Permitting Decisions- Environment Agency Initiated Variation

We have issued an Environment Agency initiated variation for Midland Oil Refinery operated by Midland Oil Refinery Limited following a review of the permit in accordance with Environmental Permitting (England and Wales) Regulations 2016, regulation 34(1).

The variation number is EPR/GP3135SD/V008.

Under the previous permit, the emission table stating the point source emissions to air from the installation read as follows:

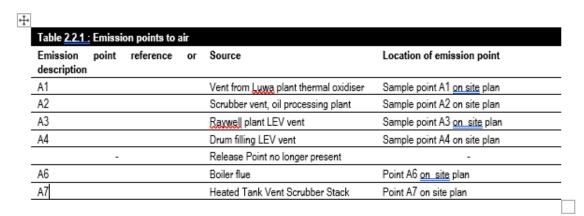
Emission points A1, A3 and A4 are point source emissions from solvent regeneration activities. Emission points A2 and A7 are point source emissions from oil re-refining activities. Solvent regeneration activities are currently non-operational and emission points A3 and A4 are now redundant and have been removed from the permit as this equipment no longer exists on site. We have added emission points A8-A10 in the permit for emissions from heating tanks used to heat waste oils for the purpose of recovery; channelled to activated carbon filters. We have added emission points for vented storage tanks.
